Alternative Scheme Proposal:

The following alternative scheme proposal has been suggested by a respondent to the consultation:

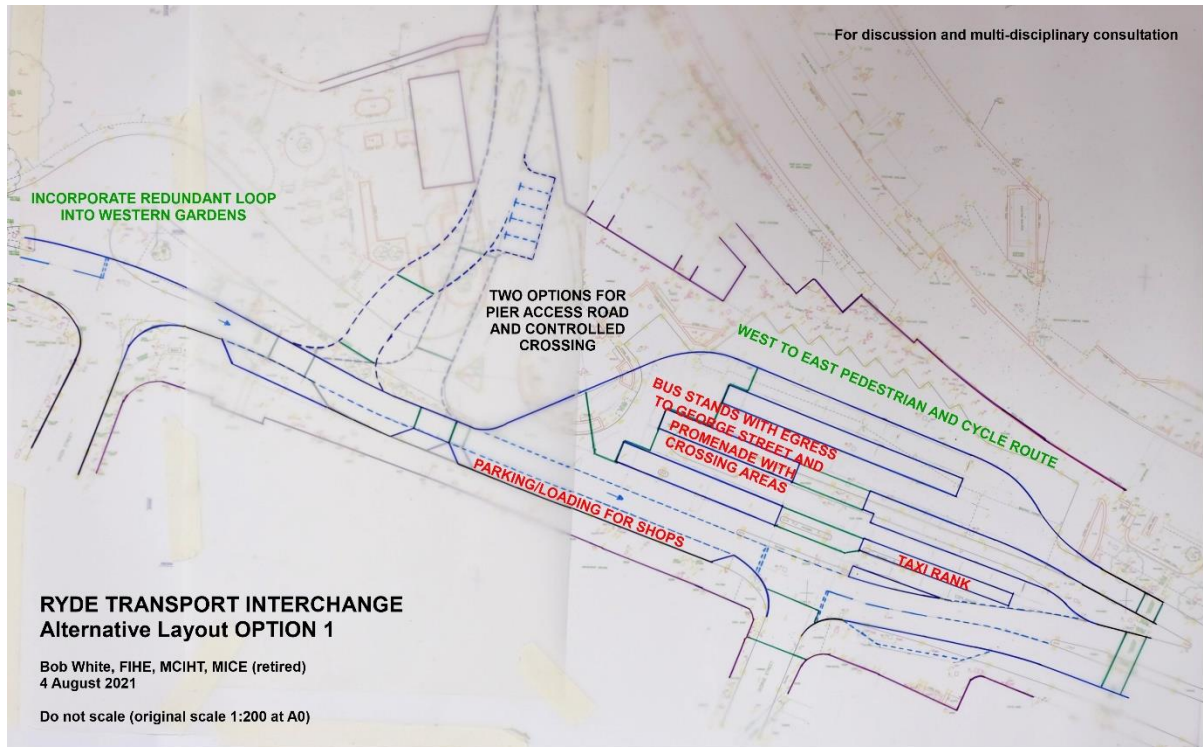
This option does not present a credible alternative or suggest any need for a fundamental review of the intended approach having a number of inherent weaknesses:

1. It modifies the Esplanade to one way traffic flow eastbound between Union Street and St George Street. As a consequence traffic approaching the pier from the east or travelling though to access the car parks in St Thomas Street would need to divert via either Dover Street or George Street, Melville Street and Union Street. This would introduce additional vehicles movements into the town centre with the consequent implications for air pollution and road safety.

2. It does not provide sufficient bus stands to the west of George Street to allow services to exit directly to George Street and so avoid the diversion via the roundabout at Dover Street

3. It does not provide safe pedestrian routes to access either the bus bays served from the central island nor taxi rank.
4. It does not provide central islands of sufficient width to accommodate bus shelters and seating or scope for planting thereon.

5. It introduces 4 different exit points from the bus station / taxi rank to the Esplanade with consequent scope for emerging vehicles to obstruct visibility.

6. It introduces an uncontrolled cross roads at the George Street junction with priority for buses leaving the bus station although visibility of / for these will be obstructed by buses waiting at the layby closest to the carriageway with no clear priority and scope for confusion / conflict between buses emerging from that layby and both eastbound traffic and buses emerging to access George Street

7. The comparatively few bus movements from the bus station to George Street and uninterrupted view of the road ahead for eastbound traffic is likely to lead to drivers not perceiving the junction / right of way for buses accessing George Street and lead to conflicts between those.

8. It introduces a curve in the west bound carriageway alignment on the approach to George Street making it impossible for vehicles emerging from the loading bay to see approaching traffic.

9. It retains the end on parking bays at the pier exit retaining the scope for conflict between vehicles leaving the pier and drivers emerging from the bays with limited visibility.

10. It removes the signal controlled crossing of the Esplanade immediately to the east of Union Street and provides an uncontrolled crossing further to the east which does not reflect the pedestrian desire lines from the interchange to access either Union Street or George Street.

11. This crossing although provided on a raised platform will not be perceived to provide priority for pedestrians resulting in pedestrians / vehicle conflicts

12. It retains the concrete block built café and toilet block which obstruct views both of and from the listed pier contrary to the aspirations of the Town Council, Business Association and Ryde Society expressed through the Regeneration Group
